CASINO

Supplementary Information Report

*Response to Request for Supplementary Information
to the Proposal for the Casino Project
submitted by Casino Mining Corporation
on January 3, 2014*

YESAB Registry # 2014-0002

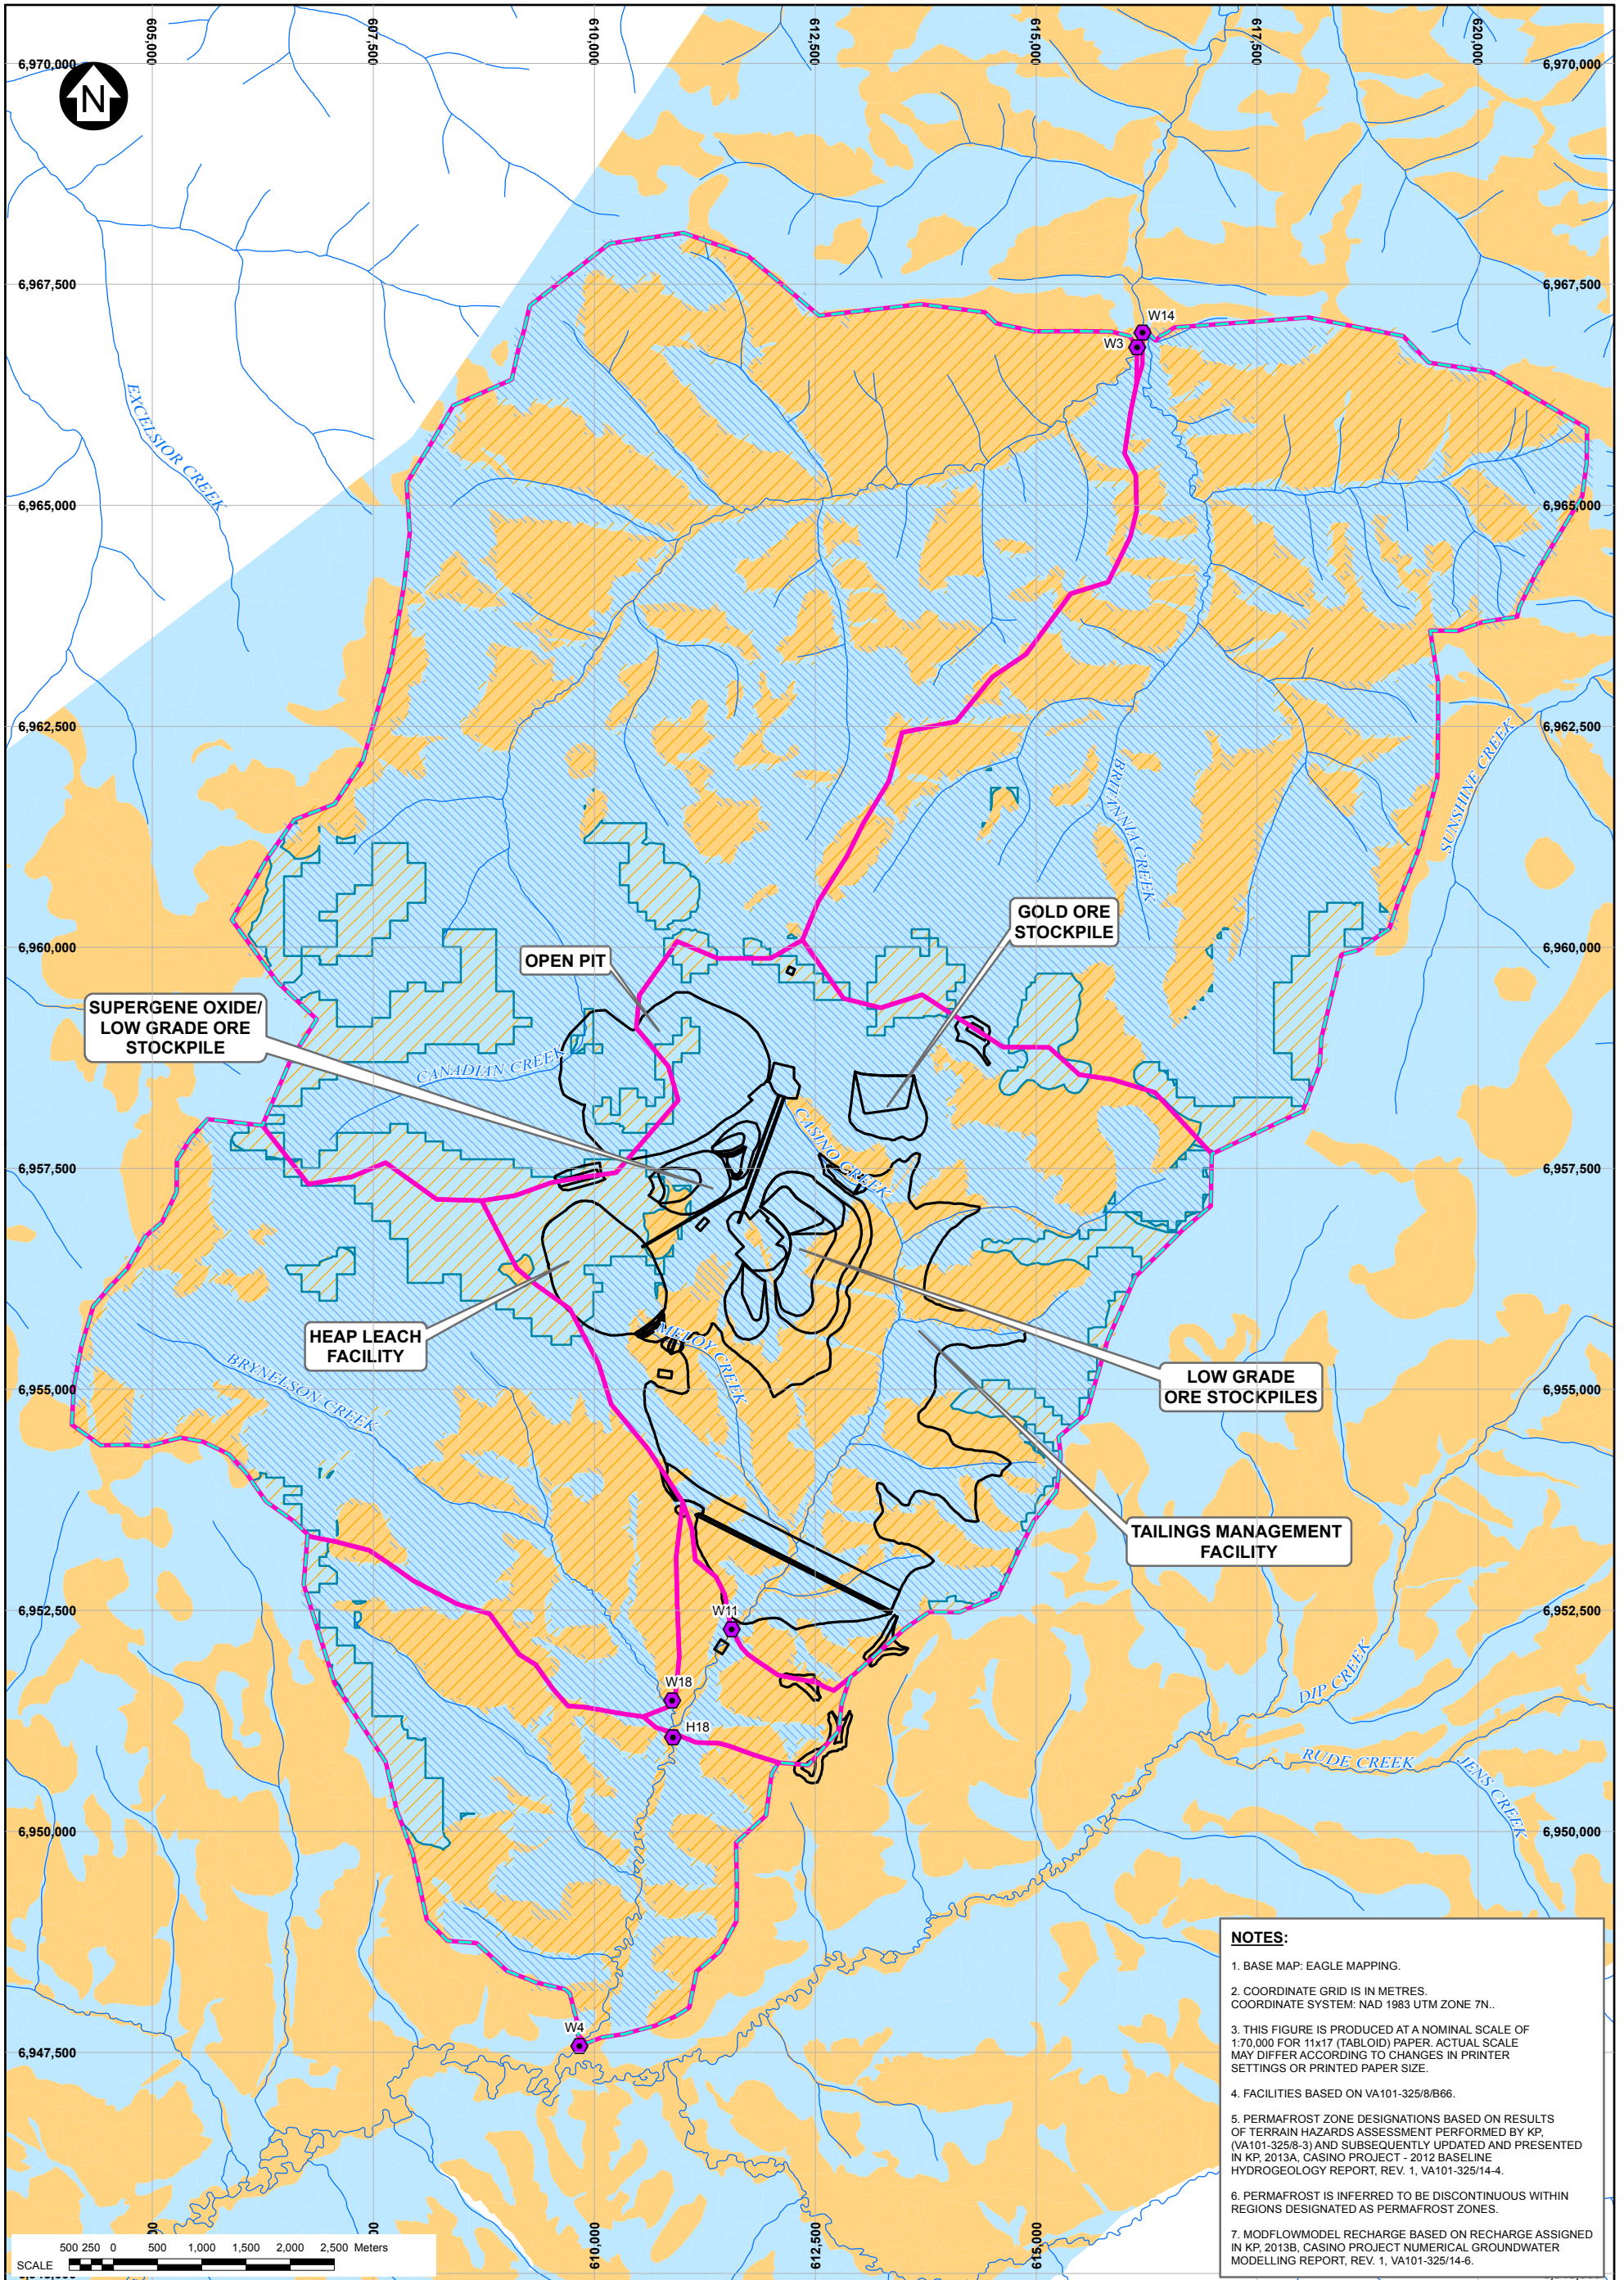
R2-113. Clarification on the most recent inferred permafrost spatial distribution (figure 2.3 of appendix 7C or figure 3.4 of appendix 7E).

The most recent interpretation of permafrost distribution at the project site is presented in Figure 2.3 of the Hydrogeology Baseline Report (Appendix 7C).
